Task Force on Partial Discharge Testing of Class I Power Transformers

Monday, April 26, 2021

**IEEE/PES Transformers Committee
Spring 2021 – Virtual Meeting**

Figure 2 —Induced voltage test for Class II power transformers

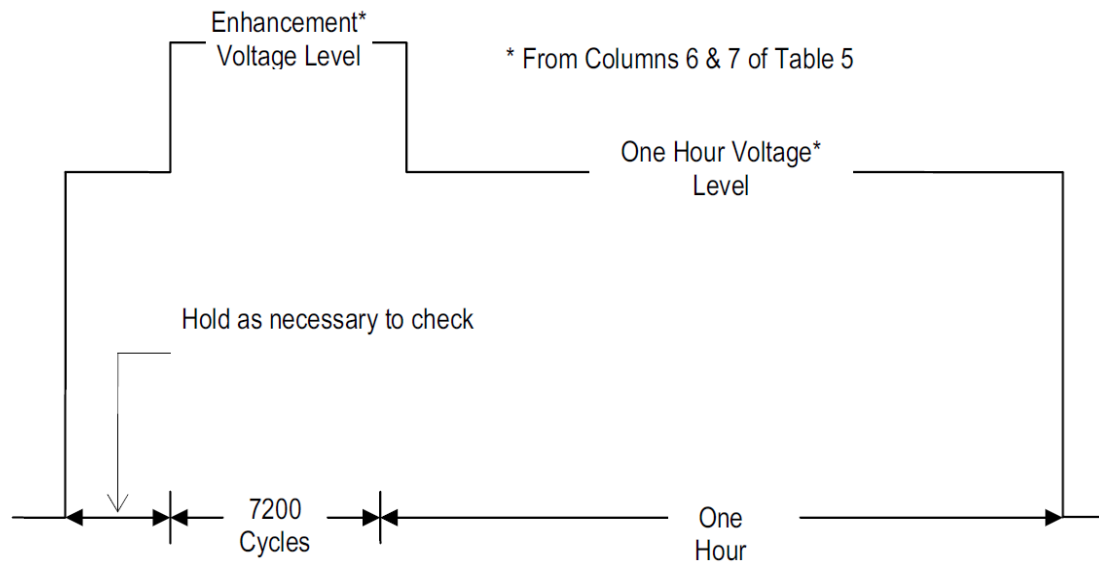
5.10.5.5 Induced-voltage test for Class II, and when specified each Class I, power transformers

With the transformer connected and excited as it will be in service, an induced-voltage test shall be performed as indicated in Figure 2, at voltage levels indicated in Columns 6 and 7 of Table 4. Minimum line-to-ground induced test levels for Class II power transformers shall be a multiple of corresponding line-to-ground nominal system voltage as follows: 1.58 times for one hour tests and 1.8 times for 7200 cycles enhancement level tests.
